**Town of Kittery
Planning Board Meeting
February 27, 2020**

ITEM 2 – 76 Dennett Road – Sidewalk/Street/Landscape Design Discussion

Action: Approve or deny street, sidewalk and landscape designs. Owners William J. Cullen and Sail Away, LLC and applicant William Wharff were granted preliminary plan approval on September 26, 2019. That approval was granted with conditions, one of which was to present sidewalk designs per the requirements of Title 16. Applicant will also present street design and landscape design. Agent is Shawn Tobey, P.E. Hoyle, Tanner & Associates, Inc

DENNETT ROAD LAYOUT PLAN
C13
 PROJECT NO. 569200
 SHEET 13 OF 28

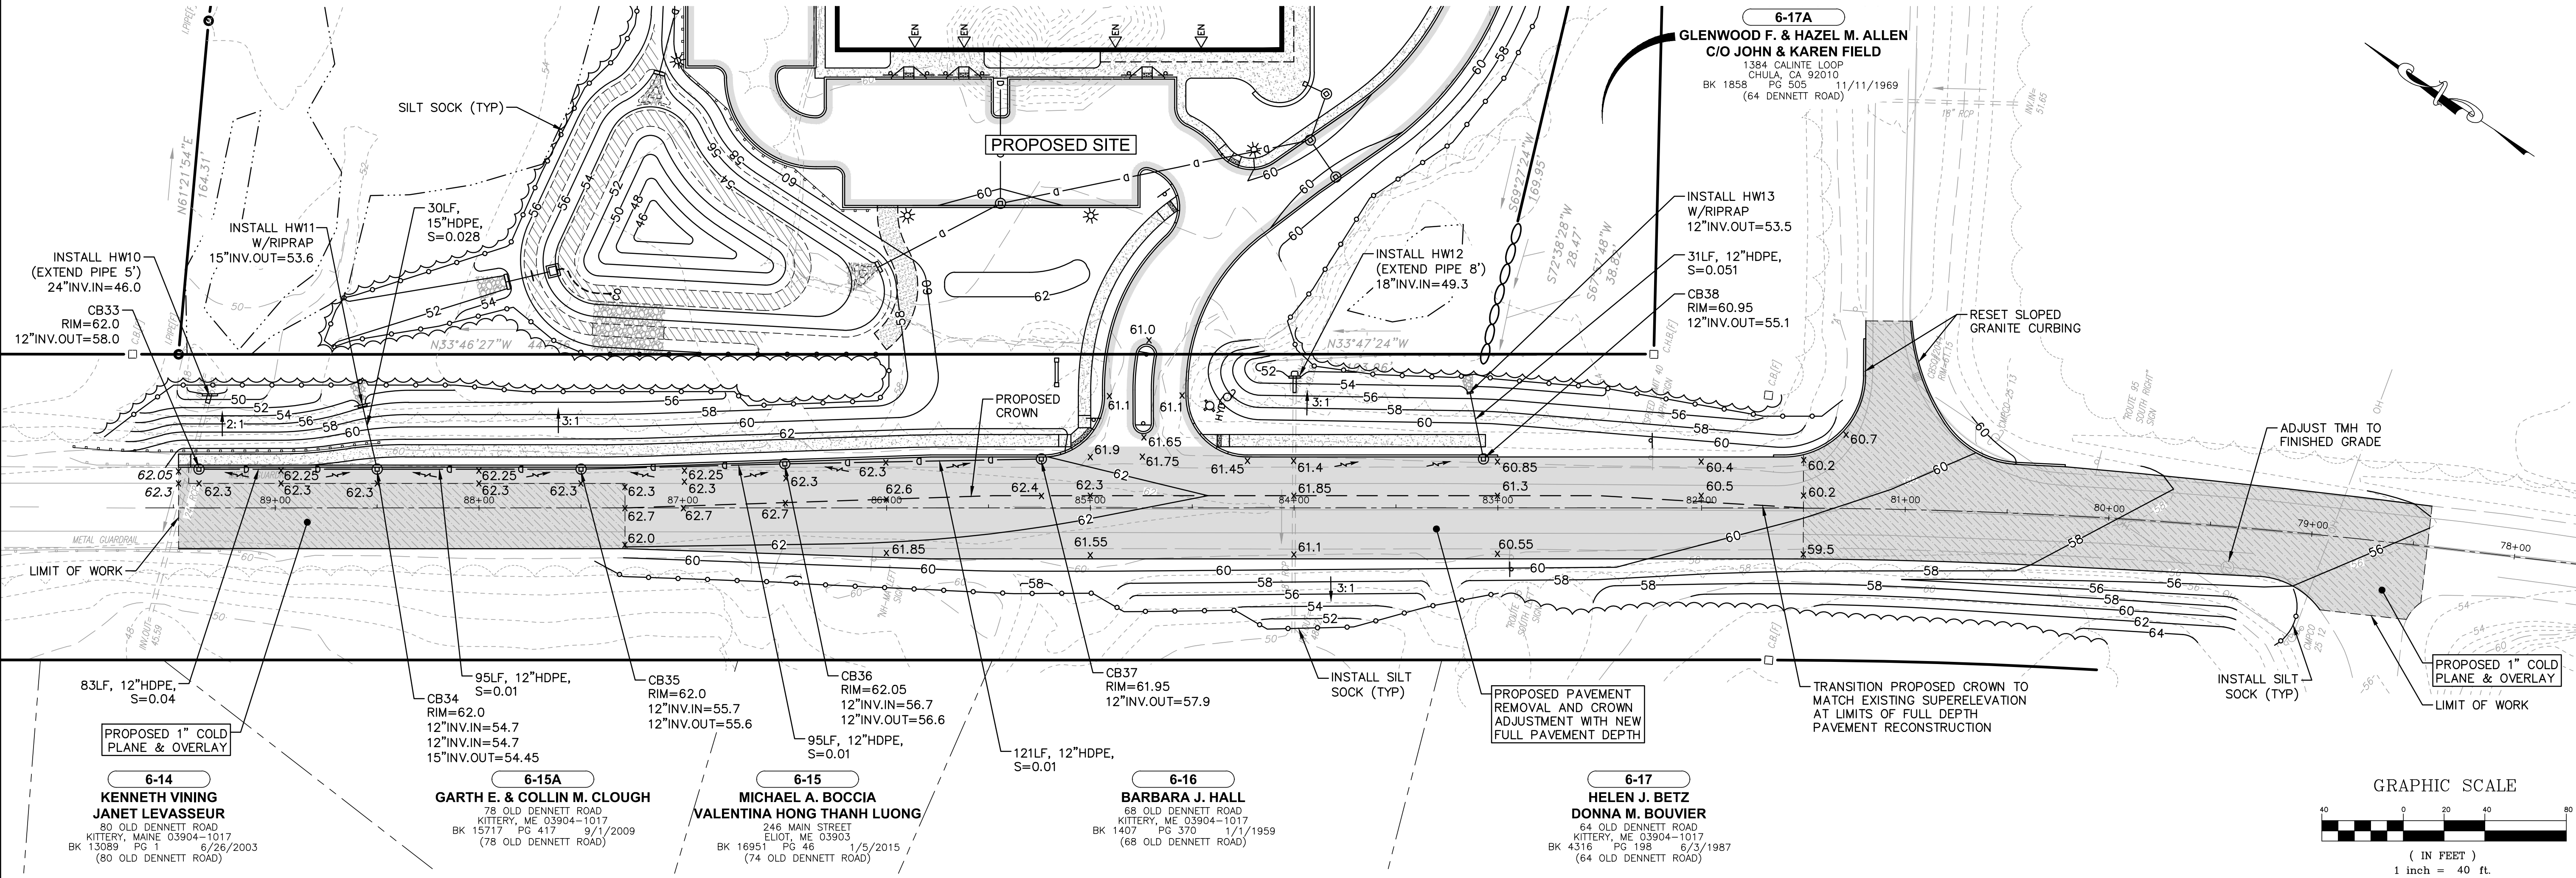
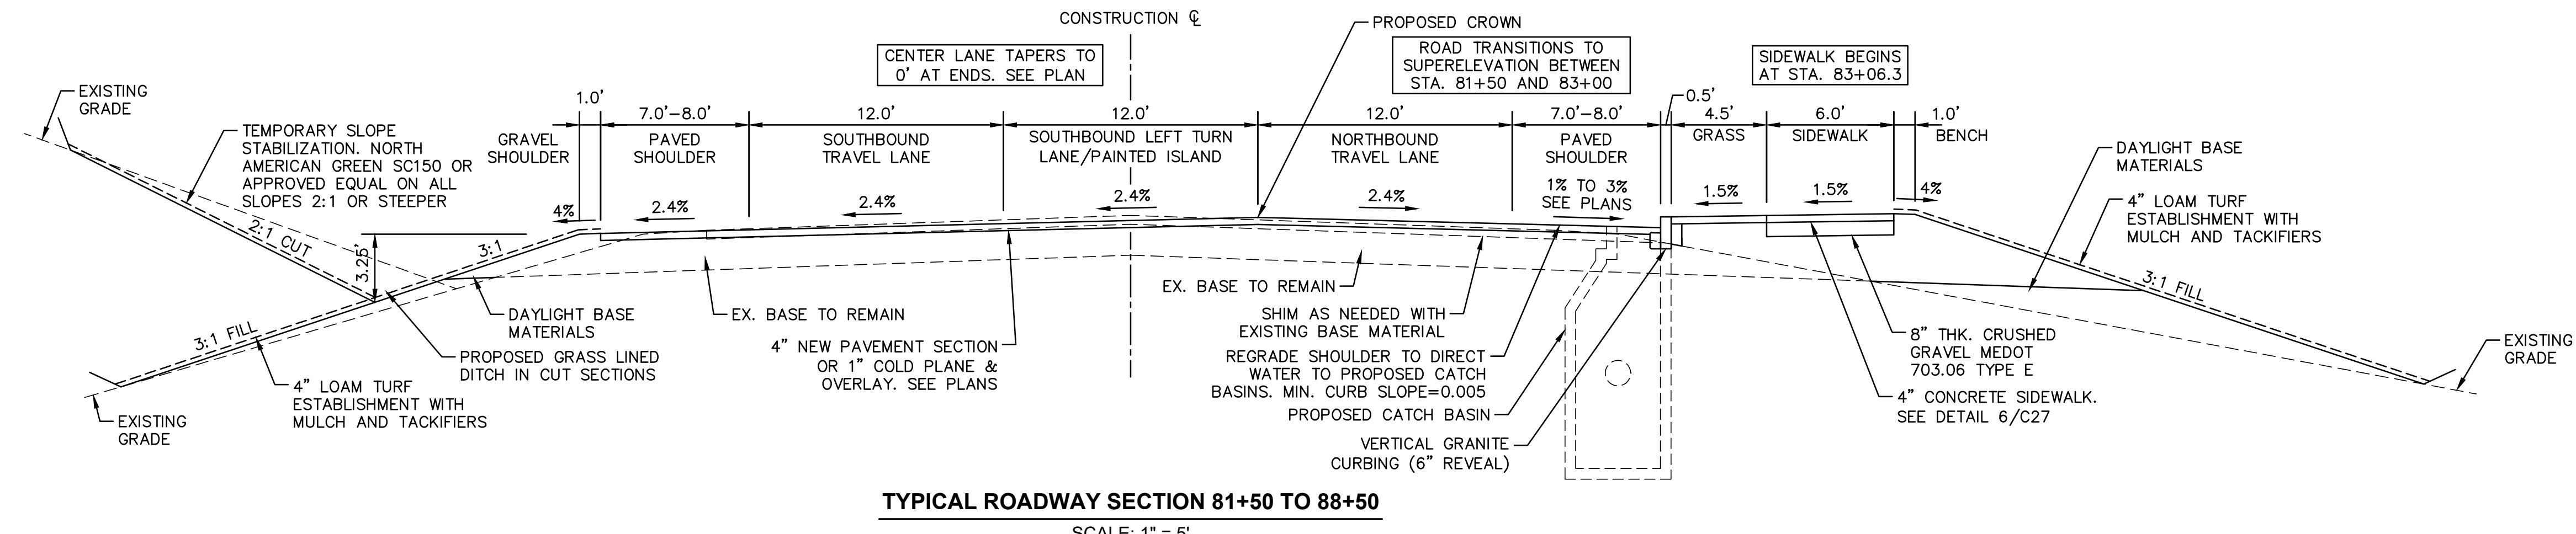
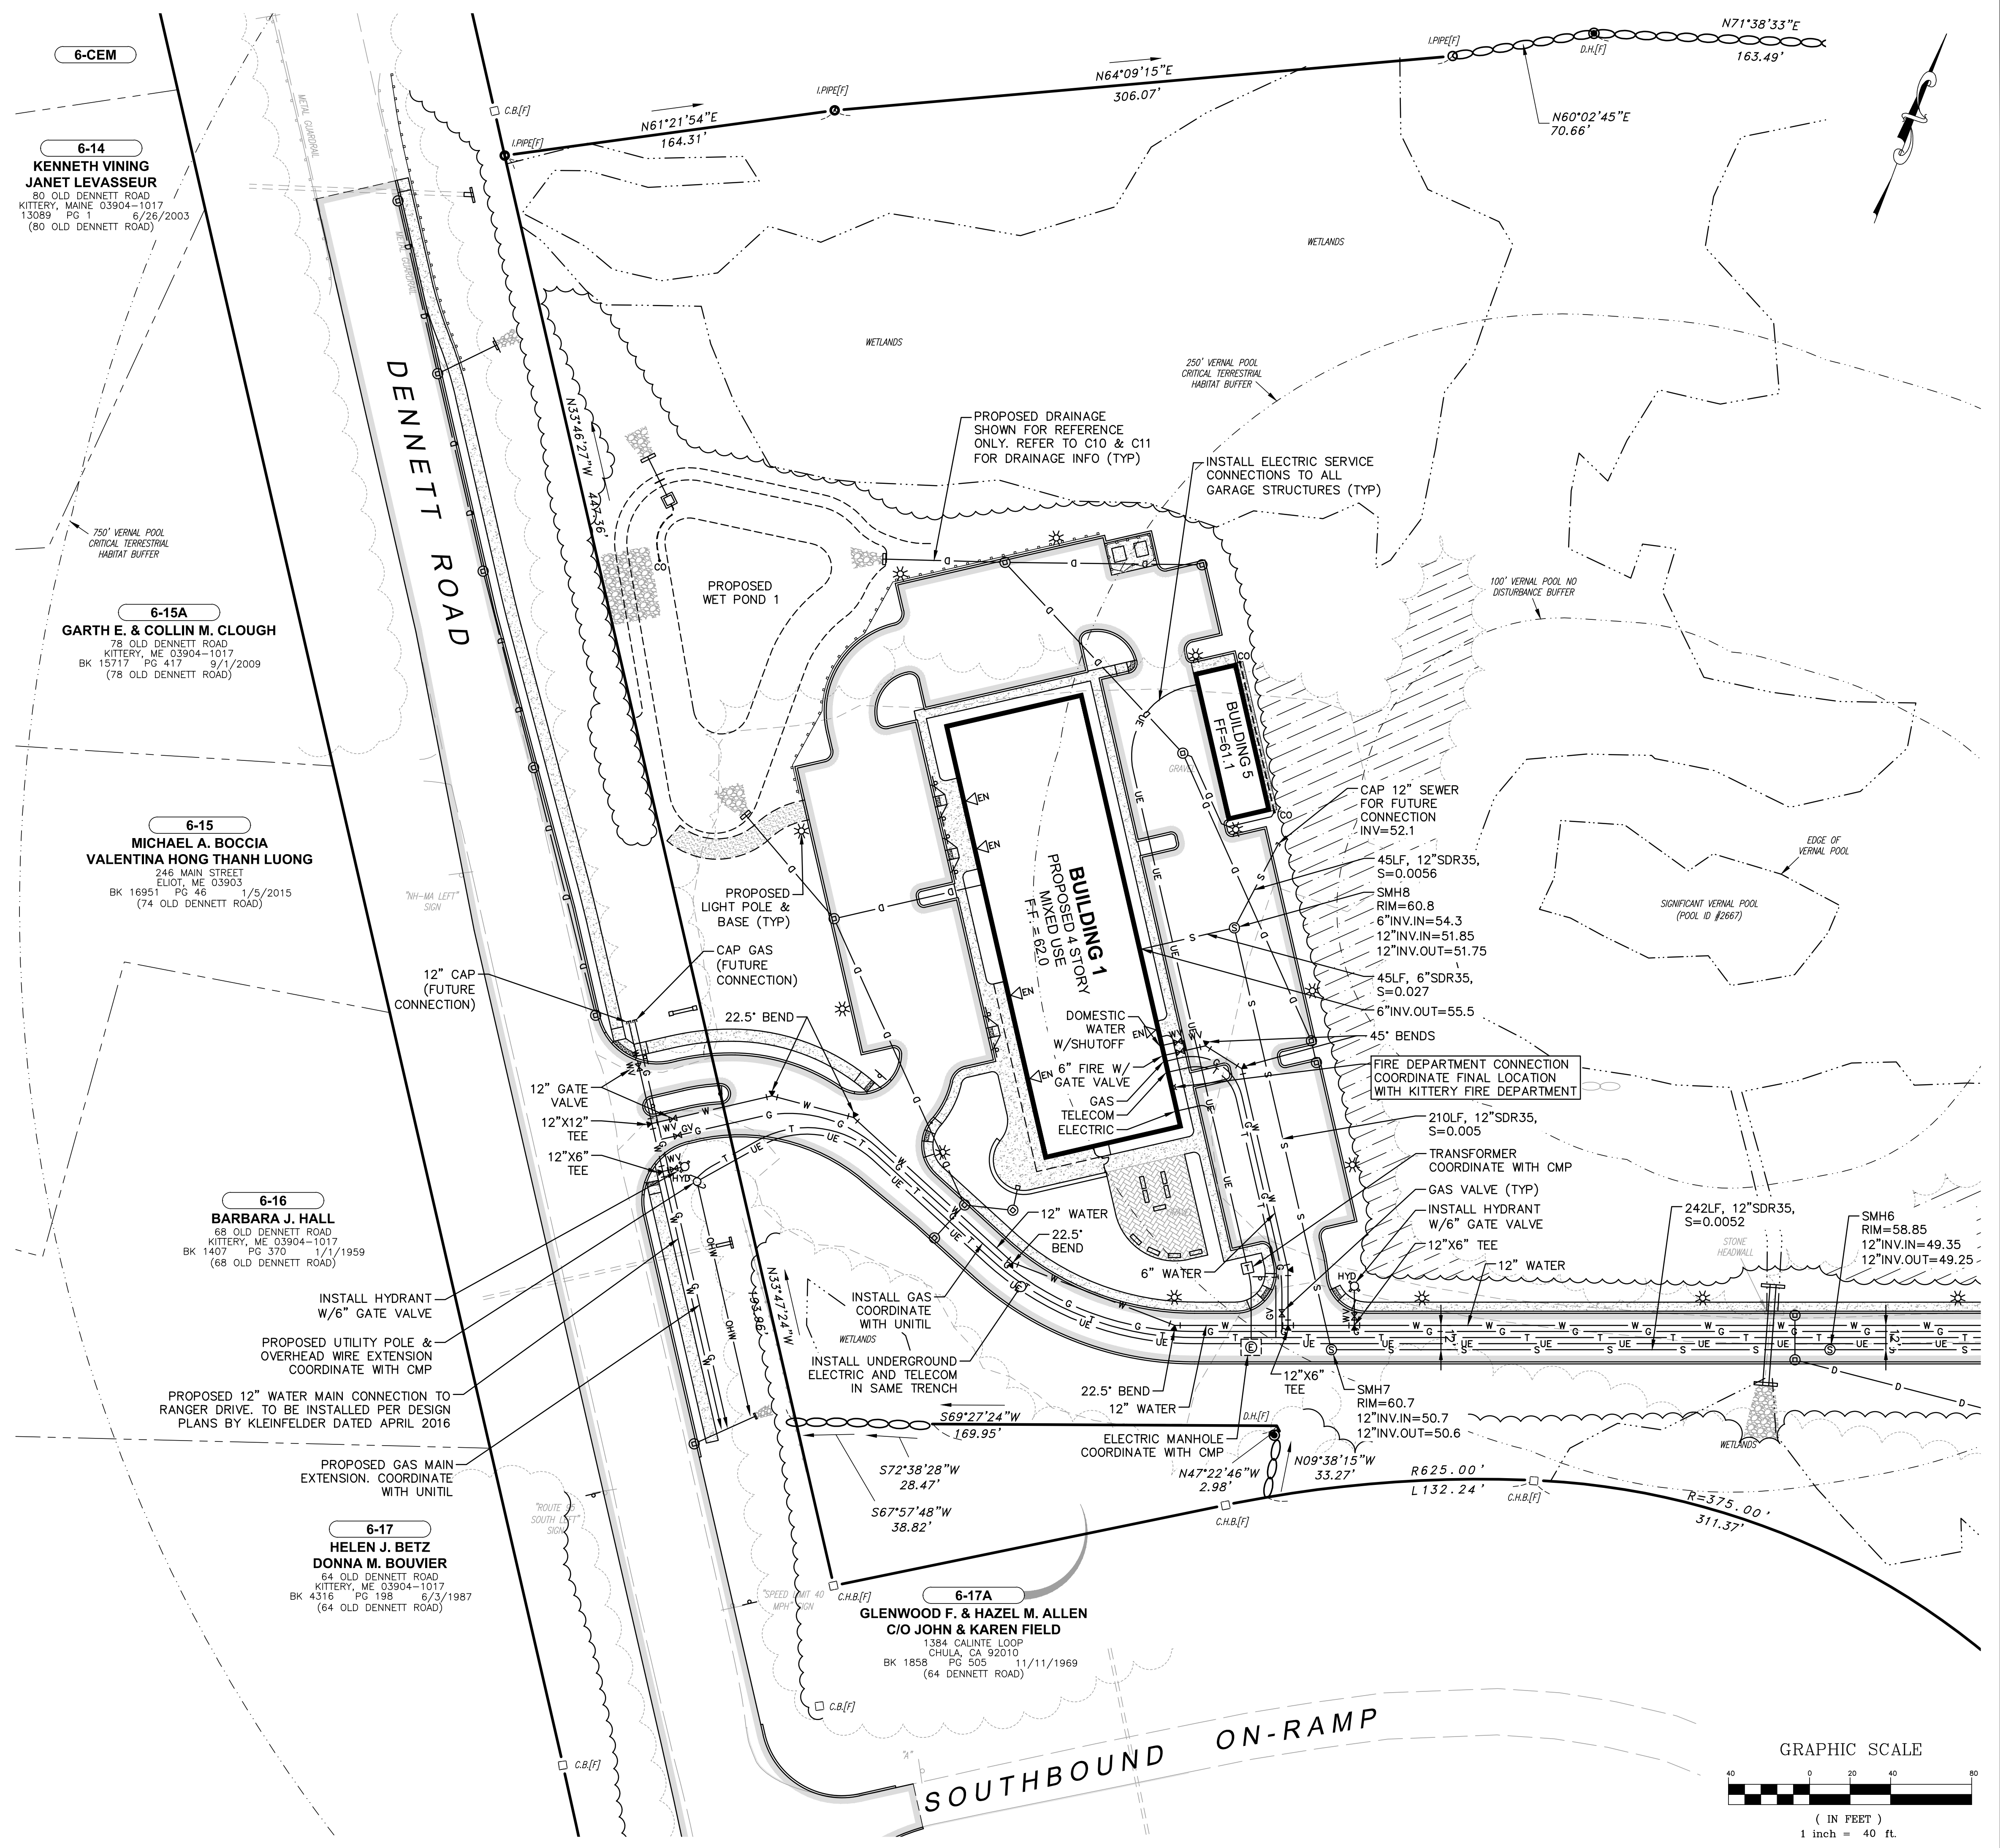
Sidewalk Design

1. From the proposed development's entrance north, for most of the way, a 6-foot wide sidewalk with a 4 ½ foot grass strip between the vertical granite curbing and the 8-foot shoulder on the other is proposed. Along the final section to the property line, the sidewalk runs adjacent to the shoulder with a guard rail on the other side.
2. From the proposed development's entrance south, a six-foot wide sidewalk is proposed with a 4 ½ foot grass strip between vertical granite curbing plus the 7-foot shoulder.

The plan shows the vegetation removal and grading involved with the sidewalk installation.

Street Design

The Applicant received comments back from the MaineDOT Traffic Movement Permit (TMP) Application.

1. MaineDOT is requiring a dedicated left-turn lane for vehicles wishing to enter the I-95 southbound ramp from Dennett Road and it appears on the plan. A five-foot wide shoulder is also required on the south-bound side of the road – the plans show an 8-foot wide shoulder coming from the north, tapering to a 7-foot shoulder at the southern end.
2. The right-turn access lane into the development is not being required by MaineDOT because the speed limit on Dennett Road is not great enough (it must be 45 mph to require such a lane and Dennett Road is 40 mph). The Applicant does not propose a right turn lane – instead taking advantage of the freed space by proposing consistent 6-foot wide sidewalks, a wider shoulder (useful for bicycle travel) and for ¾ of the frontage, a 4 ½ foot grass strip between the sidewalk and the curb.

Because of the unusual circumstances with the cancelled meeting and the Applicant wishing to move ahead to address MaineDOT's review and the Town's requests, there wasn't time for CMA, the Fire Chief, Police Chief and DPW to look at the plans. Staff will ensure that appropriate review is done and process is followed.

- The roadway design was revised to address all comments from Randy Illian's email dated February 10, 2020. The crown of the roadway was shifted to the edge of the center left turn lane, the gravel shoulders were revised to daylight into the ditch, sidewalk backslopes were revised to 3:1 maximum to eliminate guardrail or pedestrian rails, and the roadway cross slope was reduced to 2.4%.
